V2500-A1 SERIES PROPULSION SYSTEMS SERVICE BULLETIN

This document transmits Revision 3 to Service Bulletin EV2500-73-0040

V2500-ENG-73-0040

ENGINE – FUEL AND CONTROL – FUEL TUBES – FUEL METERING UNIT TO FUEL DIVERTER VALVE
SERVO TUBES RE-ROUTED

Servo tube clipping details
Figure 12

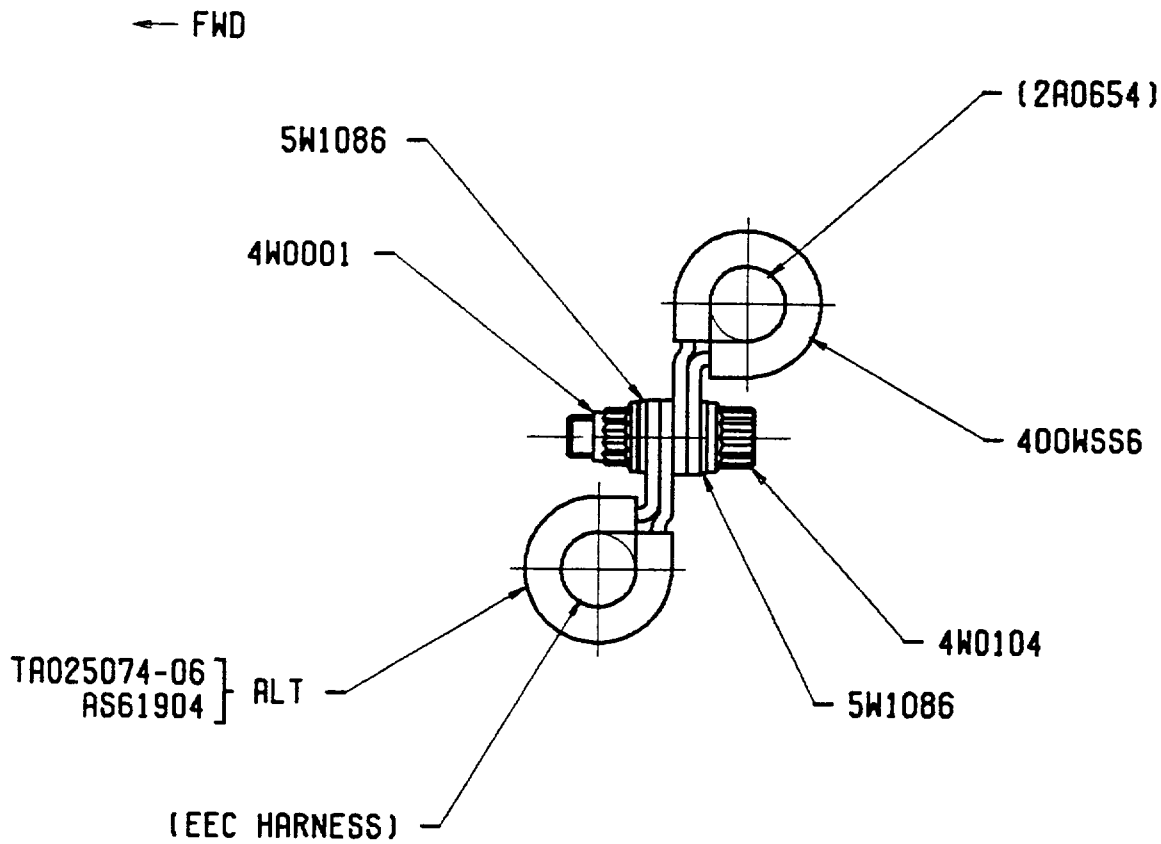
The EEC harness limb to the FMU which was supported at Clipping Point 1071 is now clipped at Clipping Point 1069. Clipping Point 1071 is therefore deleted.

Servo tube clipping details
Figure 14

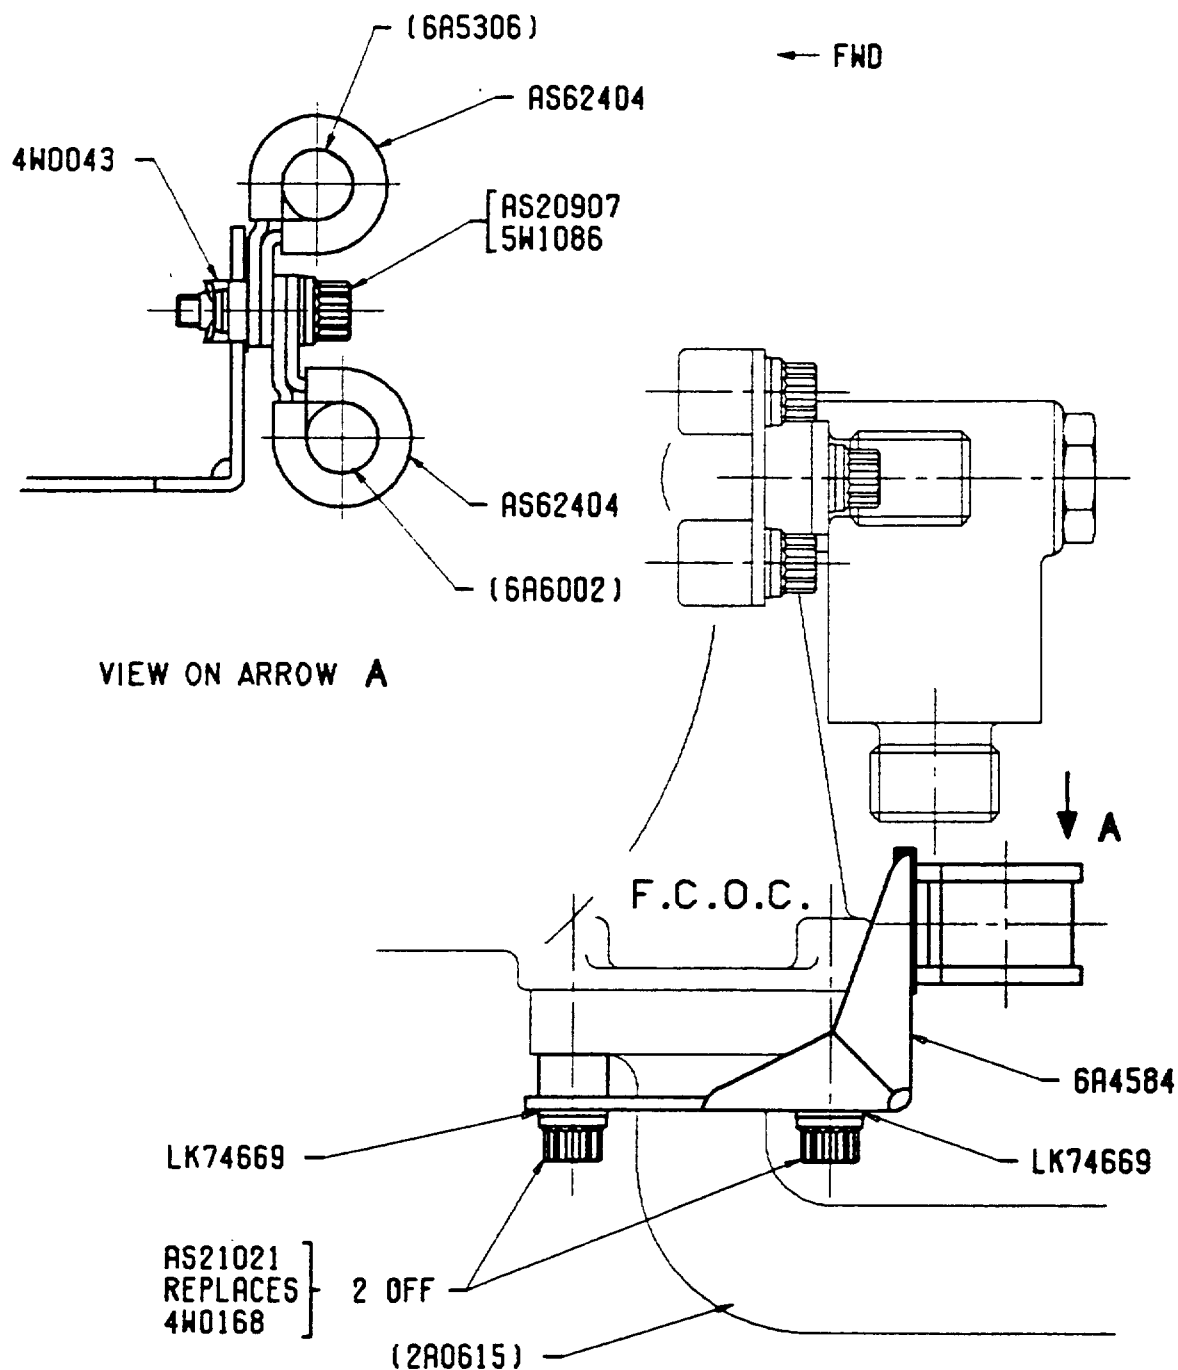
- (14) Secure 6A5306 and 6A6002 fuel tubes at new Clipping Point 1139. Install AS62404 clips to 6A5306 and 6A6002 tubes, install AS20907 bolt, 5W1086 washer through AS62404 clip on 6A6002 tube AS62404 clip on 6A5306 tube, 6A4584 bracket and 4W0043 clip nut. Torque the clip nut to 36 to 45 lbfin (4 to 5 Nm). Refer to Figures 3 and 14.

- (15) Remove 4W0168 bolt (2 off) from FC0C. Refer to Figure 14.
- (16) Secure 6A4584 bracket to FC0C using AS21021 bolt (2 off) and LK74669 washer (2 off). Torque the bolts to 85 to 105 lbfin (10 to 12 Nm). Refer to Figures 3 and 14.

Servo tube clipping details
Figure 17

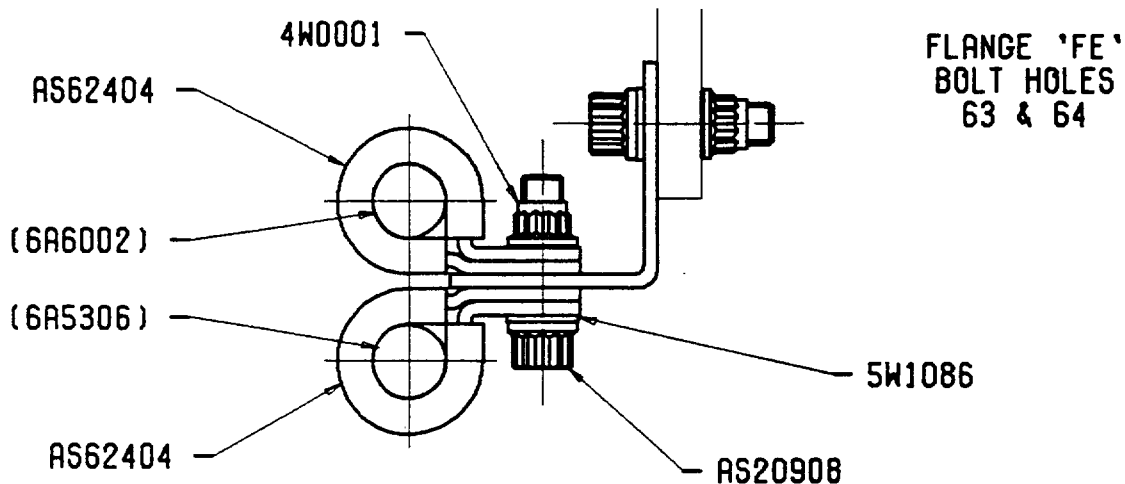
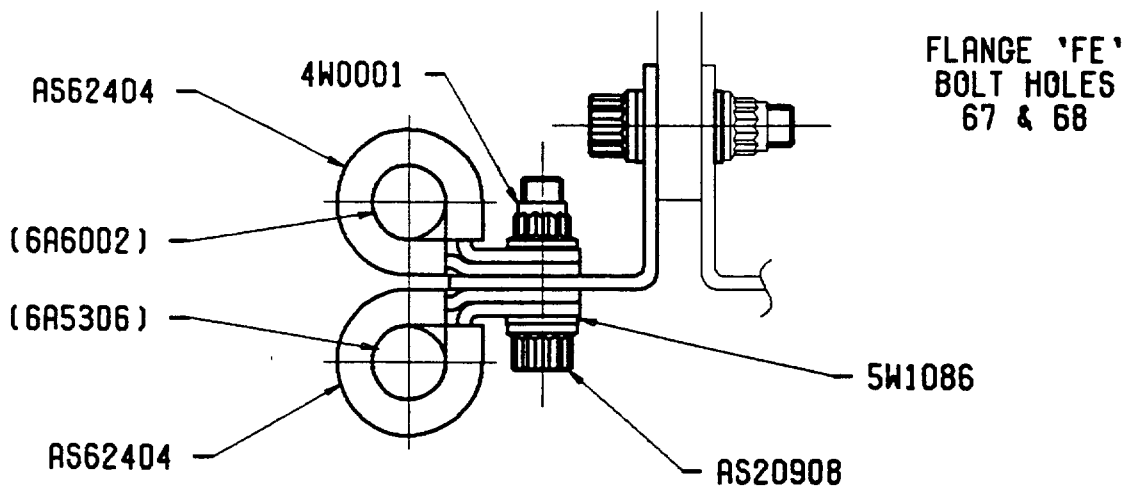
- (8) Secure 6A5306 and 6A6002 fuel tubes at new Clipping Point 1158. Install AS62404 clips to 6A5306 and 6A6002 tubes, install AS20908 bolt, 5W1086 washer through AS62404 clip on 6A5306 tube, 6A3125 bracket, AS62404 clip on 6A6002 tube and 4W0001 nut. Torque the nut to 36 to 45 lbfin (4 to 5 Nm). Refer to Figures 3 and 17.

- (10) Secure 6A5306 and 6A6002 fuel tubes at new Clipping Point 1159. Install AS62404 clips to 6A5306 and 6A6002 tubes, install AS20908 bolt, 5W1086 washer through AS62404 clip on 6A5306 tube, 6A3125 bracket, AS62404 clip on 6A6002 tube and 4W0001 nut. Torque the nut to 36 to 45 lbfin (4 to 5 Nm). Refer to Figures 3 and 17.

Rework of exisating IDG cooling tube assemblies
 showing position of deleted lugs
 Figure 18

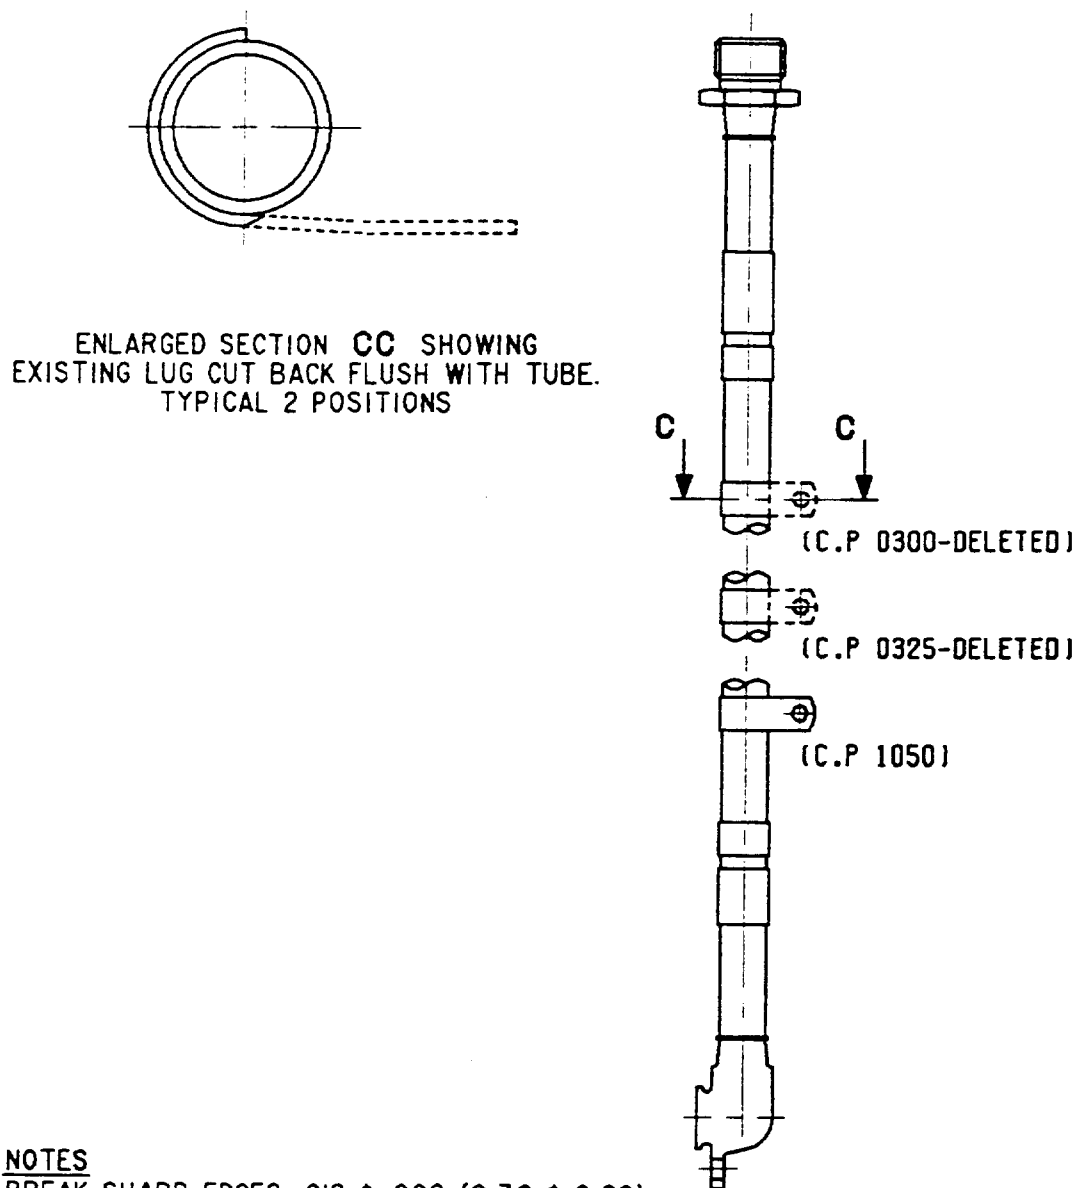
- (b) Cut back lugs to align with tube

- (c) Cancel the old part number and re-identify with the new part number

Old Part Number	New Part Number
740-5727-509	740-5727-513
740-5727-511	740-5727-513
